EX PARTE REEXAMINATION COMMUNICATION TRANSMITTAL FORM

Notice of Intent to Issue Ex Parte Reexamination Certificate	Control No.	Patent Under Reexamination	
	90/008,881	4,924,257	
	Examiner	Art Unit	
	James Menefee	3992

Notice of Intent to Issue Reexamination Certificate

This is a reexamination of U.S. Patent No. 4,924,257 (“the ‘257 patent”). Original patent claims 1, 4-7, 10, 13, and 15-19 are under reexamination. As described in the Order Granting Reexamination, claims 2-3, 8-9, 11-12, 14, and 20-22 are not being reexamined. This action is in reply to Patent owner's Response filed 8/22/2008 (“Response”).

FIG.3

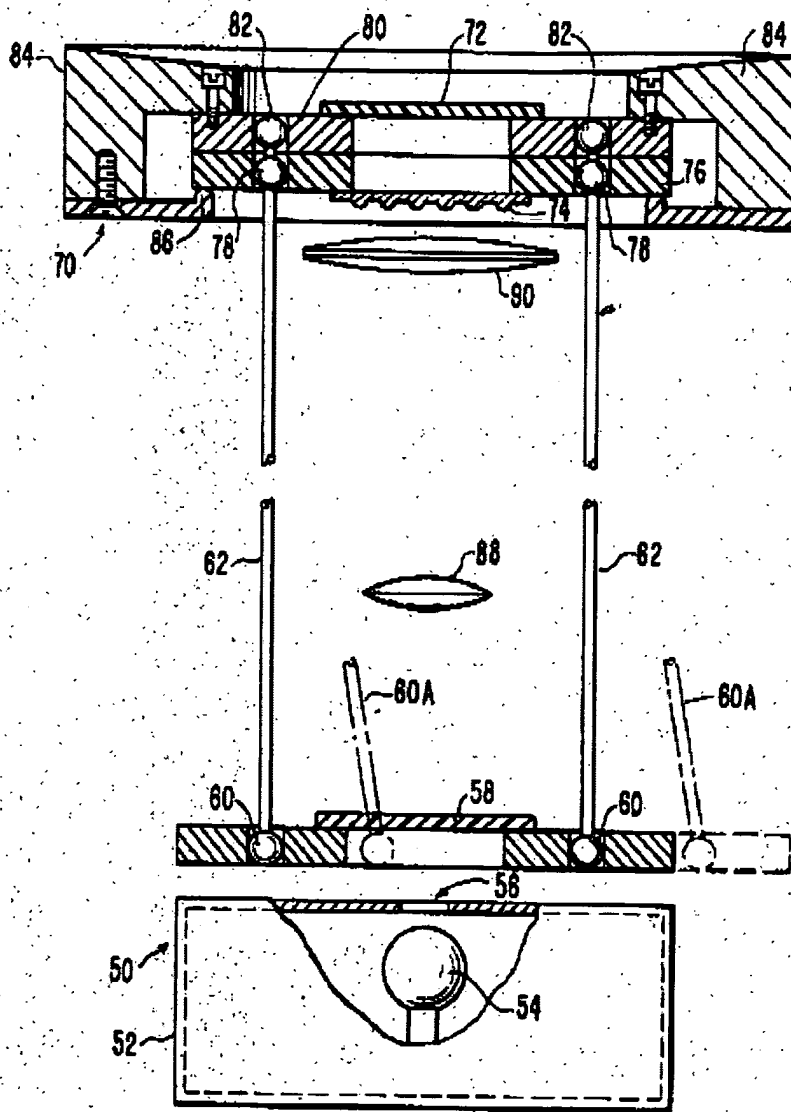
As shown in Fig. 3, light source 54 illuminates master pattern 58 to provide an image onto multiple image lens 74 to provide an exposure onto photosensitive medium 72. Arms 62 are moved to scan the pattern 58 with the light source to provide the exposure. Photosensitive medium 72 is supported on block 80 that is fixed in place via a pair of bolts.

The photosensitive medium 72 corresponds to the substrate of the '257 patent. Due to the fixed nature of this medium, these embodiments of Genovese cannot meet the limitations of the

claims of scanning the substrate and moving the substrate stage. '257 patent claims 1 and 17, limitation (a).

To meet these limitations, the Request proposed that it would have been obvious to move the stage 80 having the photosensitive medium 72 of Genovese in light of Genovese's description in Figs. 2A-2C of the "basic scanning principle of the invention" where both the master and the photosensitive medium are moved. See, e.g., Request p. 56. The examiner disagrees, and agrees with the Patent owner. First, Figs. 2A-2C are not necessarily embodiments of Genovese, but are just basic principles of how scanning may operate in Genovese.¹ With nothing else, the examiner *would* find it obvious that Genovese's first and third embodiments could operate in such fashion. The examiner agrees, however, with Patent owner's arguments that Genovese teaches away from moving the photosensitive medium in these embodiments. Response p. 47. Genovese makes clear that mechanical matching of the elements is important to achieve good results given the fine scanning that takes place, and this is done by designing the device with "mechanical excellence." Col. 6 lines 16-25. The examiner agrees with Patent owner, Response p. 47, that such mechanical excellence and stability of the system is achieved, at least in part, due to the fixing of the photosensitive medium in place during the scanning, as it is much simpler and would provide much less error potential to have fewer moving parts. In light of Genovese's expressed requirement that mechanical excellence is important, and the fact that Genovese expressly utilizes bolts to fix the photosensitive medium to help achieve this mechanical excellence, the examiner finds that Genovese teaches away from modifying the first

and third embodiments to move the photosensitive medium. These embodiments therefore do not teach or disclose the limitations of the claims as described above.

FIG. 3

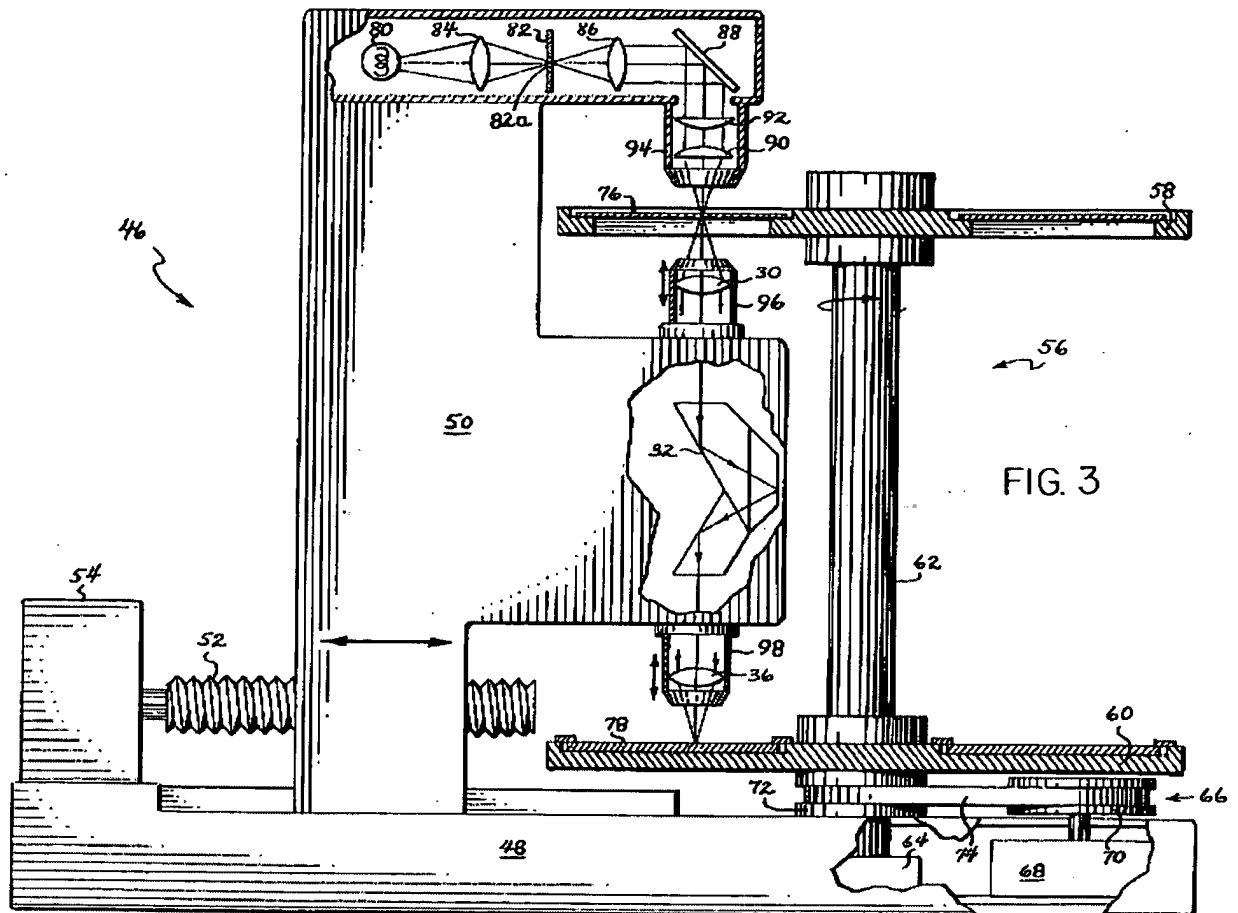
Franklin discloses in Fig. 3 a projection printer 46 having an optical system housing 50 disposed on a base plate 48. Col. 2 lines 40-42. The housing is movable bi-directionally in one dimension (i.e. left-right on the page of Fig. 3). Col. 2 lines 42-47. Housing 50 includes light source 80 for illuminating the plates (discussed below) through diaphragm 82 that may be in the shape of a polygon, see Fig. 4B. Col. 3 lines 12-30. During illumination, master plate 76 is scanned by the light to expose an image of the illuminated region on photosensitive plate 78, *id.*, similar to the '257 patent where a mask is scanned by light to produce an image of exposure on a substrate.

During illumination, plates 76, 78 are rotated on plate holders 58, 60 around shaft 62 on plate positioning system 56. Col. 2 lines 48-59. This provides a spiral scan, which Franklin states provides a uniform exposure in conjunction with the aperture 82a of diaphragm 82. Col. 3 line 31 – col. 4 line 3. Franklin states that in addition to spiral scanning, a raster scan could be used. Col. 3 lines 37-40.

The examiner agrees with Patent owner's arguments that Franklin's system of Fig. 3 could not achieve raster scanning, despite what Franklin states, due to the rotational and lateral motion as described above. Response pp. 20-21. And given Franklin's focus upon rotatable motion of the plates, the examiner finds no reason that a person of ordinary skill in the art

viewing Franklin would substitute a different scanning system, for example an x-y table, in place of the rotating plate positioning system. Even though the system of Fig. 3 is merely called a "preferred embodiment," col. 1 lines 46-48, there is no description of any other embodiments, of how or why a raster scan could be implemented, nor of how or why scanning could occur without rotation as shown. In light of Franklin's use of only rotational scanning as described in Franklin, and that raster type scanning would not work with such a device, the examiner is not persuaded that it would have been obvious to combine Franklin with references such as Feldman and Genovese to provide such raster scanning as indicated in the prior rejection.

Given that raster scanning will not work with Franklin, the examiner looks to the spiral scanning that Franklin shows. The examiner agrees with Patent owner that such scanning would not provide uniform exposure of the plates because the rotation of the plates combined with the linear movement of the light source will leave areas of non-uniformity. Response pp. 22-23. The claims require the exposure dose received across the substrate to be uniform. '257 patent claims 1 and 17, limitation (h). As Franklin's system does not provide uniform scanning in the spiral mode, and there is no reason to provide raster scanning in Franklin as it would not work (i.e. no reason to use Genovese or Feldman as in the prior rejection), the rejections based on Franklin will be withdrawn.
